PRAIRIE ISLAND NUCLEAR GENERATING PLANT
UNITS 1 AND 2

Improved Technical Specifications
Conversion Submittal

PACKAGE 3.5

JUSTIFICATION FOR DIFFERENCES FROM IMPROVED STANDARD TECHNICAL SPECIFICATIONS (NUREG-1431) AND BASES

FIGURE TS.4.4-1

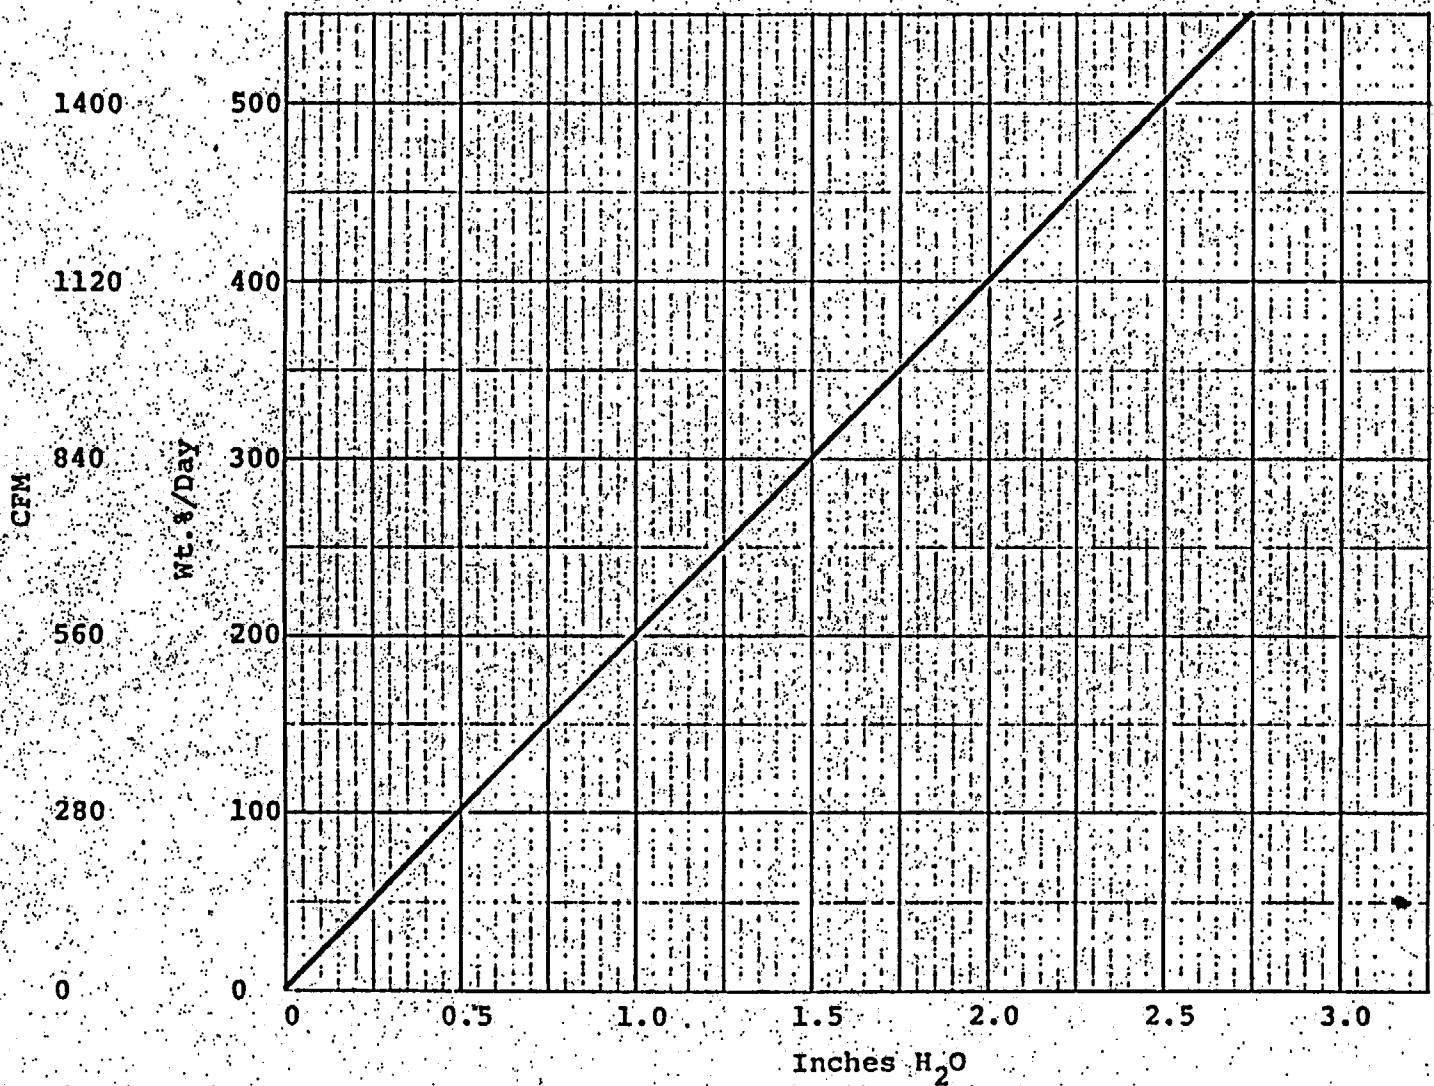
This Figure is Deleted

LR3.6-56

NSHD Category	Change Number 3.6-	Discussion of Change
	55	Not used.
LR	56	CTS 4.4.B.1 and Figure 4.4-1. Specific details of how the SBVS quarterly test is to be conducted and the input assumptions are unnecessary in the TS. Thus these CTS requirements, including the referenced figure, are relocated to the TRM. Since the TRM is under the control of 10CFR50.59, these requirements remain under regulatory controls. These changes are consistent with the guidance of NUREG-1431. As explained in the CTS Bases, these requirements result in an equilibrium pressure of -1.82 inches water gage. For clarification, the -1.82 inches water gage requirement is included in ITS SR 3.6.9.5 and its Bases.
LR	57	CTS 4.4.B.3.a, 4.4.B.3.b, 4.4.B.4.a, 4.4.B.4.b, 4.4.B.4.c and 4.4.B.5. Specific details for conduct of ventilation filter tests have been relocated to the Ventilation Filter Test Program in accordance with the requirements of PI ITS Section 5.5, Ventilation Filter Test Program. Since this test program is required by the TS, these requirements remain under regulatory controls. This change is consistent with the guidance of NUREG-1431.
